Access Compliance Report

Public Rights-of-Way

(Pedestrian Signals)

Intersection ID: N/A	Main Street:	Cross Street: N/A	Location: N/A
ADA ID: 91E9DBFAC898	Signal Type: Two Push Buttons-Non APS	Overall Compliance: No	Severity Score: BTN 1:N/A BTN 2: N/A No BTN: N/A
Codes/Mitigation Info/Possible Solution		Field Measurements/Component Compliance

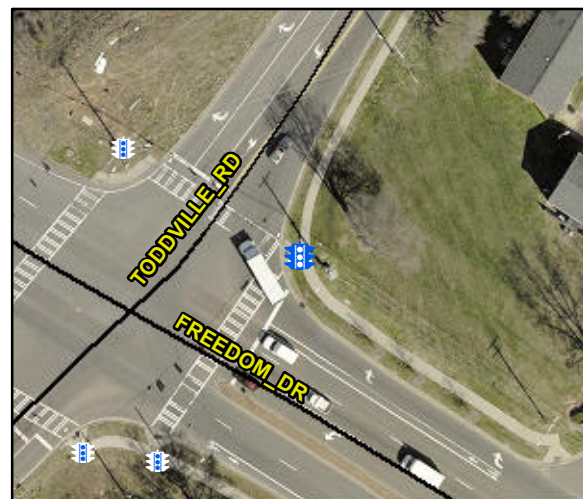
Possible Solutions: Replace Signal Push Button With APS Button on New Post. Remove & Relocate Sign.

PROW/ADA: TMUTCD 4e.08, R404.2, R404.3, R404.7.2
